# 10 Mb/s Single Twisted Pair Ethernet 10BASE-T1L Receive State Diagram (Comment #577)

Steffen Graber  
Pepperl+Fuchs

# 10BASE-T1L Receive State Diagram

Changes (in red) to:  
Figure 146-8 – PCS receive  
state diagram (part a)

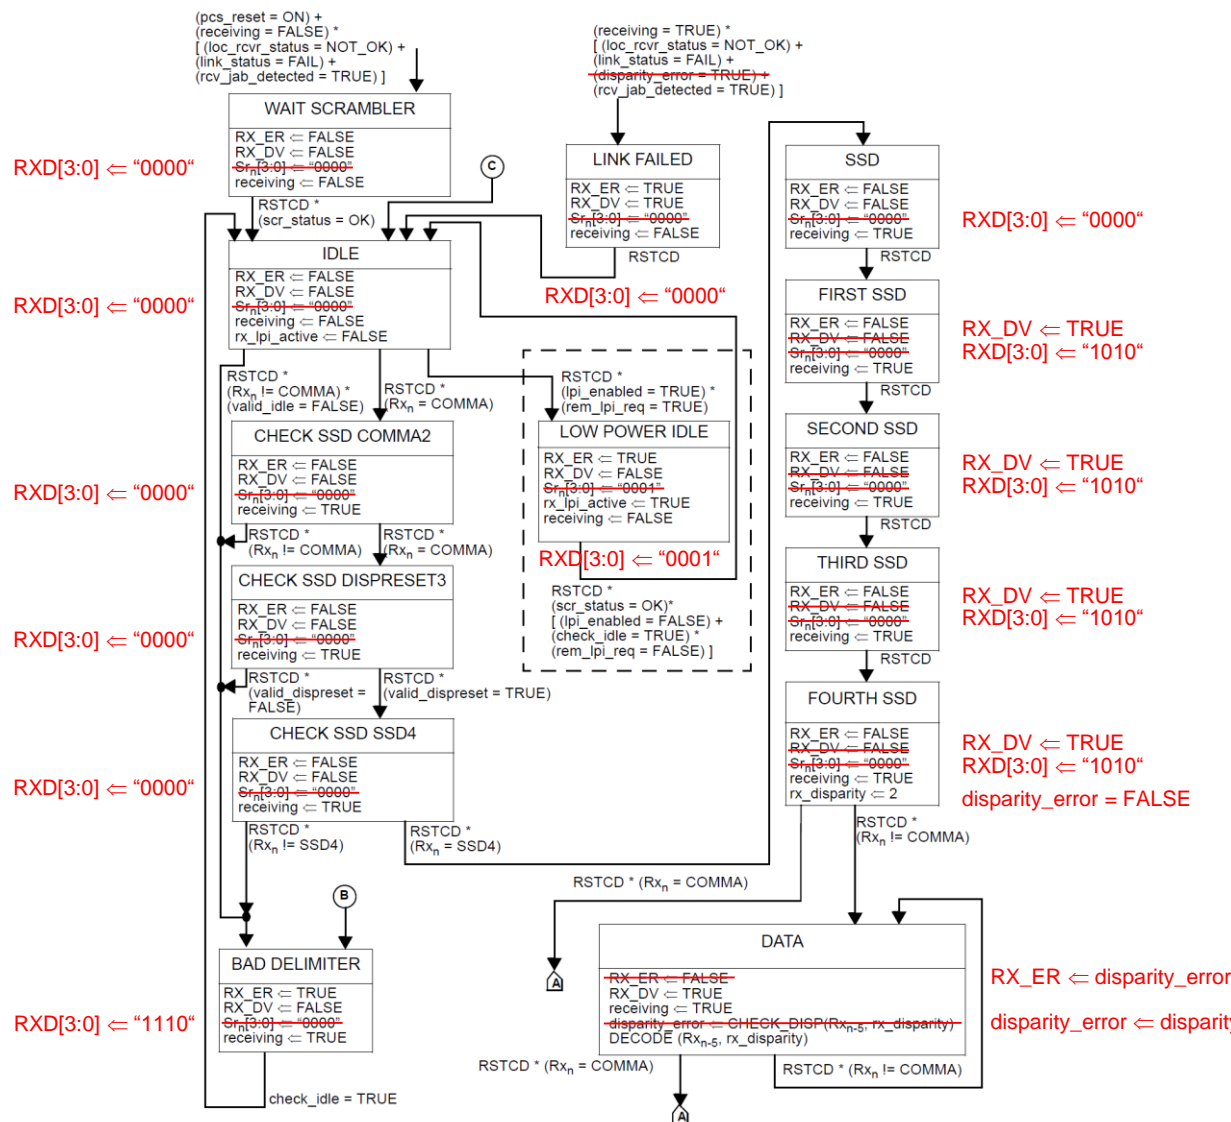
- Currently the 10BASE-T1L receive path is done in the following way:

This is the actual DECODE function in the receive state diagram.

- Therefore the Receive state diagram returns  $Sr_n[3:0]$  instead of  $RXD[3:0]$  as in other standards.
- The DECODE function in the current draft D2.0 is defined as:

$$Sr_n[3:0] = \text{inverse}_{table_{4B3T}}(Rx_n)$$

- Including the descrambler functionality it needs to be changed to:

$$RXD[3:0] = \text{descramble}(\text{inverse}_{table_{4B3T}}(Rx_n))$$

- Additionally the changes provided on the next two pages are proposed to be done:
  - These changes allow to output  $RXD[3:0]$  instead of  $Sr_n[3:0]$  and therefore support to provide the correct LPI encoding “0001” on the MII.
  - In „BAD DELIMITER“ state  $RXD[3:0]$  is encoded as „1110“, which is a „false carrier indication“.
  - Additionally the part of the preamble being replaced by the SSD is now recovered, allowing back-to-back PHY configuration, as the preamble is not shorted anymore.
  - A detected disparity error it not completely resetting the state machine anymore, going to state „LINK FAILED“, but just setting  $RX\_ER$ , which is a „less aggressive“ behavior, but still allowing to detect disparity errors.
